VMC Secondary Plan Comments

RE: SmartCentres Comments on Parks & Wayfinding Master Plan As presented at the VMC Sub-Committee October 30th, 2024

We are pleased to provide the following comments on the final Parks & Wayfinding Master Plan, prepared by Janet Rosenberg & Studio, dated October 30th, 2024. Accordingly, our comments are as follows:

Figure 1 – VMC Master Plan (Figure 52 on Page 104)

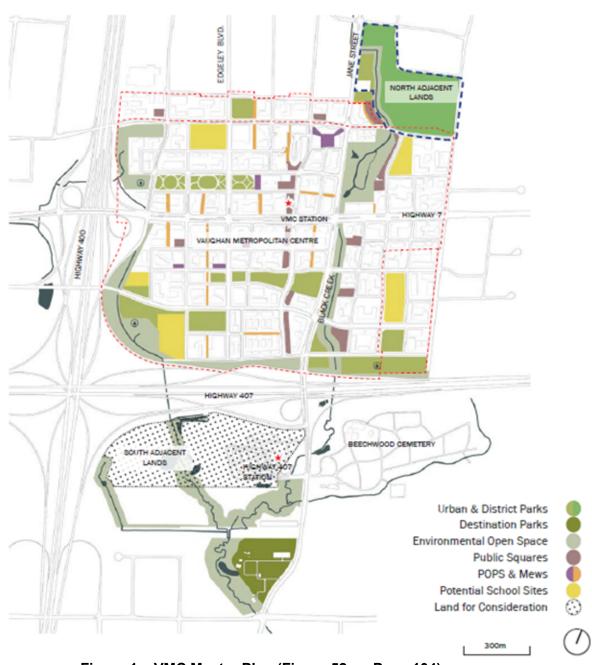
Mews and	
Flexible	
Streetscapes	
Page 100 -	A substantial portion of our lands are designated as a <i>Potential School Site</i> .
4.4.4	Given the policy directive to look at alternative designs which reflect an
	urban, high-density neighbourhood, this mapping is not appropriate. The
School Sites	large amount of lands identified makes an assumption that the school site in
	a suburban model, which is directly contract to Page 101 of the report, which
	notes that Canoe Landing is used as an inspiration. It is our request that
	potential school sites continue to be identified by a symbol similar to the
	current VMC Secondary Plan rather than mapping out a potential site plan
	for each school site as these locations are subject to a consultation process
Dama 400 40	with the City of Vaughan, SmartCentres and School Board.
Page 132 – 4.9	Block A6 (City File OP.22.004) is subject to active planning applications for

VMC Full	the deletion of the E-W Local Road and we request this be deleted on the
Parks Master	plan.
Parks Master Plan	Block C2 (City File OP.20.012) is subject to active planning applications for
FIGII	the deletion of the N-S Local Road and we request this be deleted on the
	•
	plan.
